Summary of Comments on TIS County Comments 10-15-18 w LSC Responses.pdf

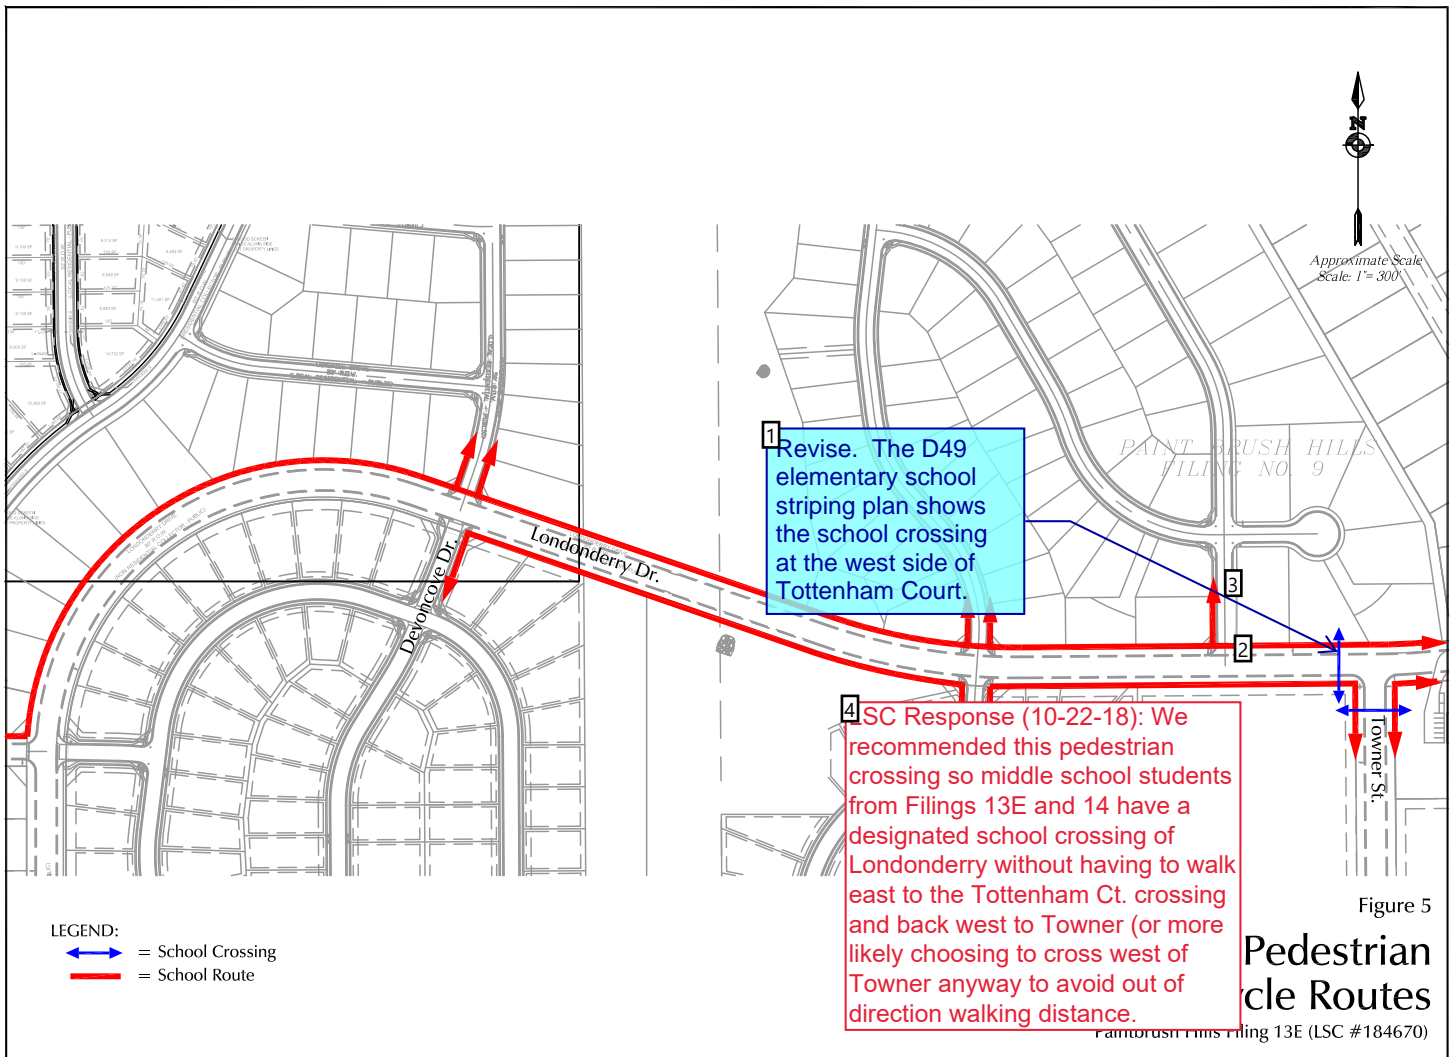
158 lots per the filing
13E plat.

LSC Response
(10-22-18): This has
been corrected in the
updated report.
